# **BLOCK 10 & 11, SECTION 100 CANBERRA CITY** **ARCHITECTURE DESIGN REPORT**

Rev:	Issue / Amendment	Date
01	- Issued For Works Approval Submission	01-07-2021

## Response to National Capital Design Review Panel's Advice Blocks 10 & 11, Section 100 City

Aerial view showing One City Hill proposed development in the foreground with indicative massing for future stages of the The Barracks precinct behind with the courts precinct on the right

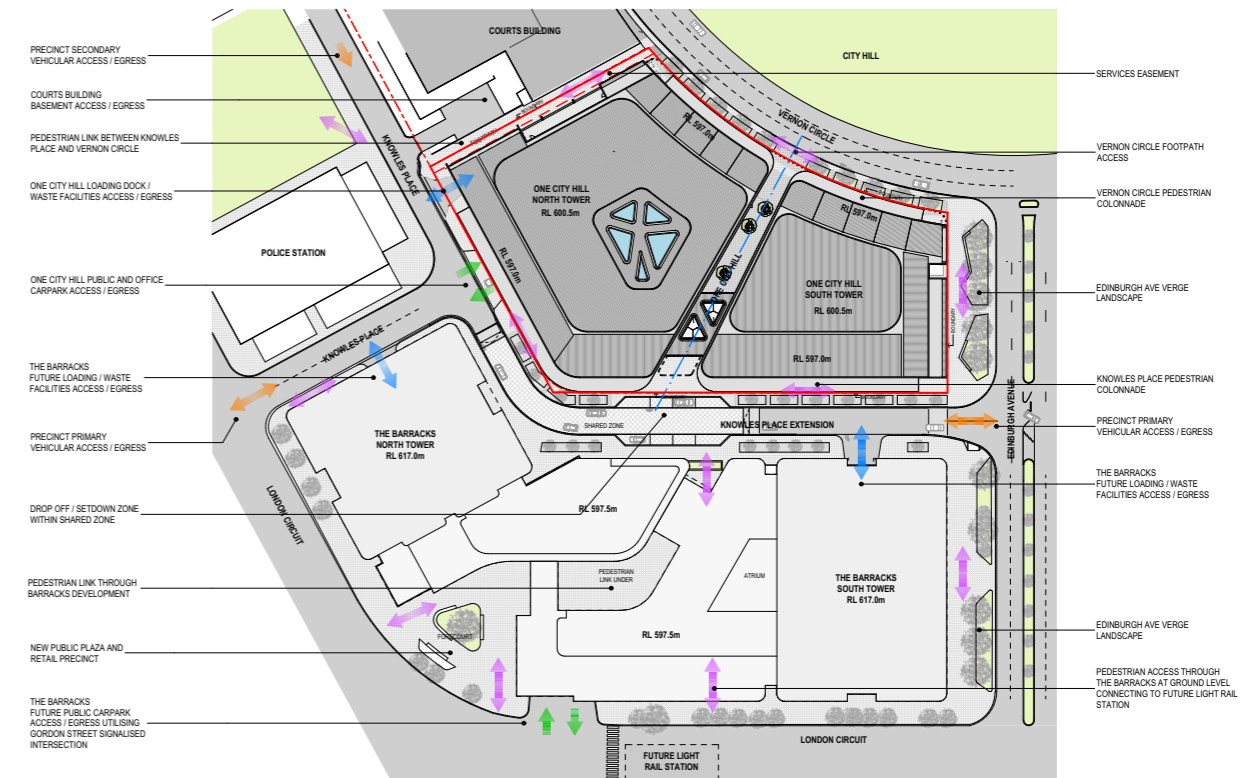
1.1 *The Panel notes the prominence of the site situated opposite City Hill and at an apex of the National Triangle and further notes its proximity to the Canberra city centre and the newly developed ACT law courts precinct. The proponent is encouraged to engage in further analysis of the surrounding character and immediate context which should inform the site response and architectural form and expression of the proposal. The Panel notes that the building ought to develop a more civic presence and expression, however the glazed northern and southern facades are considered to be more typical of a commercial precinct. The Panel encourages the proponent to consider how the proposal may respond to the street*

wall scale on Vernon Circle, and key datum lines, height, materiality and colours of the neighbouring Supreme Court of the ACT building; and how it can be scaled and articulated in order to provide a more sympathetic, authentic and finer grained response to the predominantly civic character surrounding the site.

The Vernon Circle frontage has developed significantly with major changes to the massing of the building as well as development of the façade design. The sectional profile along Vernon Circle reflects the following significant initiatives:

- The top level of office is now set back to provide an alignment more closely matched to the Supreme Court of the ACT building height profile;
- The plant room is further set back from the top office level;

- A double height pedestrian colonnade developed for the full length of the Vernon Circle frontage, providing a generous open building edge;
- Vernon Circle façade gently folds at the centre in a major gesture of articulation;

- Louvres are expressed along the prominent portion of façade separately from the recessive portions of façade;
- Louvre 'skirt' provides a sense of some spatial enclosure to the colonnade while remaining open;

- The metallic cladding of the Supreme Court building is complemented by the louvre materiality and positioning;
- The two Vernon corners are rounded in lieu of angled corners, providing better pedestrian circulation around the building;

- The Vernon Circle car drop off area has been deleted, providing an uninterrupted pedestrian path.

Precinct masterplan showing the relocation of the vehicular access / egress to edges allowing for improved central shared space along Knowles Place

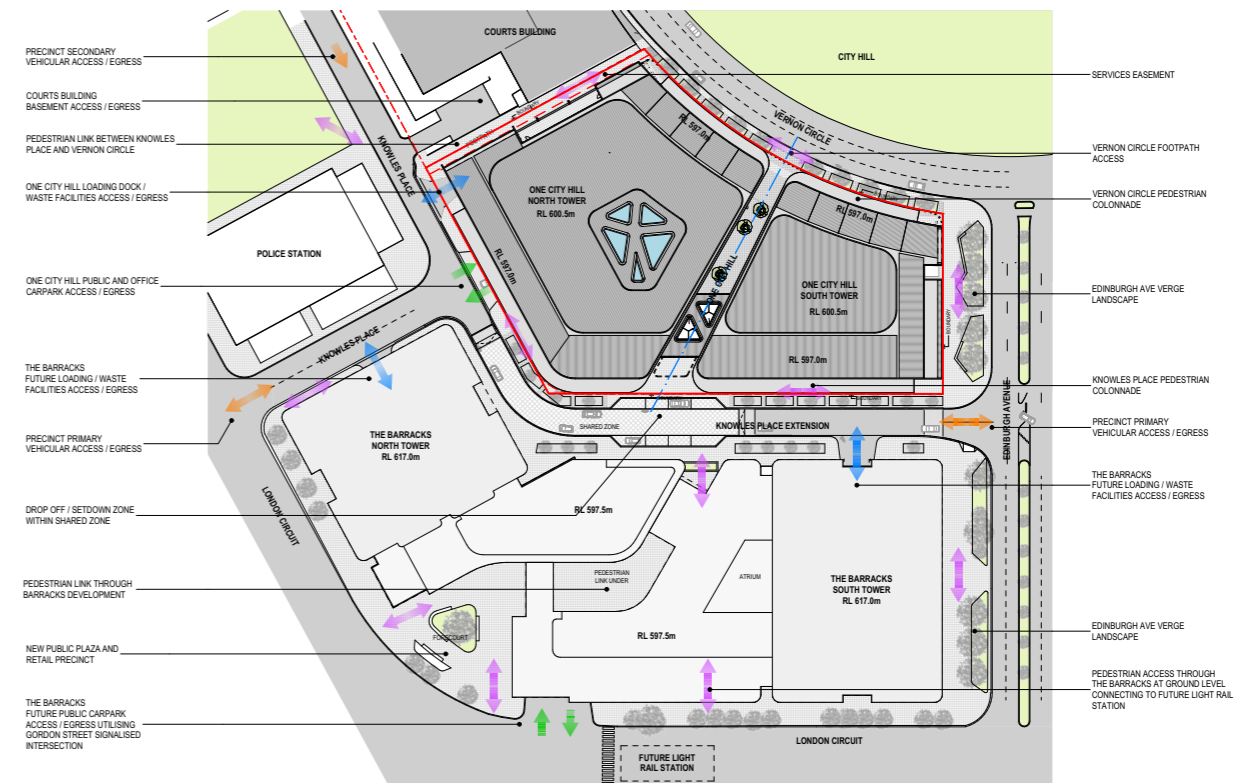
2.2 *The Panel considers a much more civic approach is required in the public domain interface that responds to the significance of the location and reinforces the continuity of the public domain, particularly in relation to the proposed future stages.*

The public domain has been the prime focus of the re-planning of the building frontages. Car parking has been removed from the ground level (Knowles Place level) and the numerous required services have been re-planned to be within the ground level floor plate, including:

- Waste storage & loading;
- Substation orientation;
- End-of-Trip facility access off Edinburgh Avenue;
- Reduction of crossovers;
- Forward-in, forward-out for truck access, with only one loading dock crossover;
- Fire services relocated off the Knowles Place frontage.

The retail frontage has been significantly enhanced by consolidating into two major zones in lieu of three smaller zones. The Edinburgh Avenue retail corner has been enhanced with a flat paving zone to both frontages allowing street café style use.

The Knowles Place and Vernon Circle frontages have been developed into premium pedestrian zones with double-height colonnades providing a balance of shelter and openness.

Images showing the original building massing (left) with the proposed development massing (right).

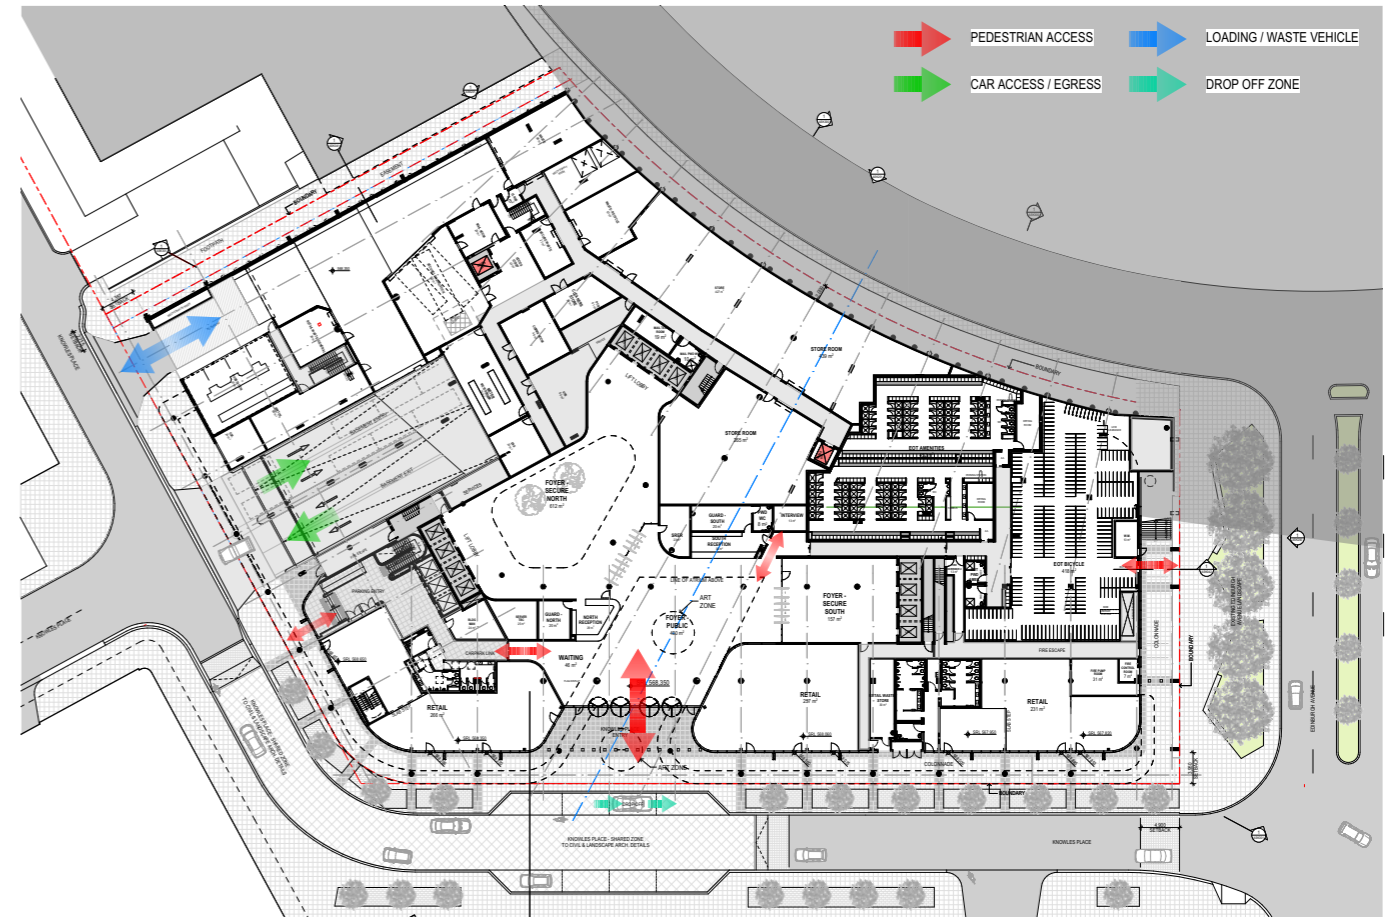
5.1 *The Panel commends the proponent's intention to provide a landmark building and civic response for the site, however the Panel is concerned that the current proposal presents as an unrelieved, singular mass. The Panel acknowledges the previous development approvals for the site with respect to height and massing however considers that the current proposal for a single building without significant modulation in the building form or articulation does not adequately respond to its context, nor support a high-quality public domain. The Panel therefore encourages the proponent to explore options that provide greater modulation and articulation to the building and façades, including options that suggest two parallel building forms potentially articulated by a more continuous skylight and intersected by the cross axis of the pedestrian link, rather than a singular form in order to provide a finer grain urban form.*

6.1 *The Panel is concerned that the proposed Knowles Place loading and basement entries provide an unsatisfactory termination the Knowles Place extension, and present as substantial breaks in the continuity of the streetscape and appear to run counter to the intention for a vibrant, well-activated shared zone. The Panel therefore encourages the proponent to explore options to minimise the vehicle crossovers to support the successful implementation of the future shared zone.*

The buildings separation into two towers, with the two façades broken down into smaller scales relieves the massing originally proposed.

Main building entry can be easily identified by the two storey glazed entry atrium from which access to either tower is provided. Retail space flanks both sides of this entry and is linked to the public zone of the entry foyer and internal access from the public basement carpark.

The building's loading dock has now been relocated to the northern end of the building, where a previous basement exit ramp was located. This results in an uninterrupted, activated retail frontage to the majority of Knowles Place, a much improved design outcome. All basement entry and exit points are located at the future intersection of Knowles Place Central, Knowles Place South, and the Knowles Place Extension, near the ACT Policing building. This is the optimal location for this entrance from a traffic movement perspective, minimising driveway crossovers to Knowles Place, and allowing the area of raised Shared Zone for pedestrians to be maximised.

The relocation of the loading and waste facilities to the north end of the site co-locates these services with those of the adjacent courts building and separates pedestrian, retail and office activities allowing for improved retail amenity along Knowles Place.
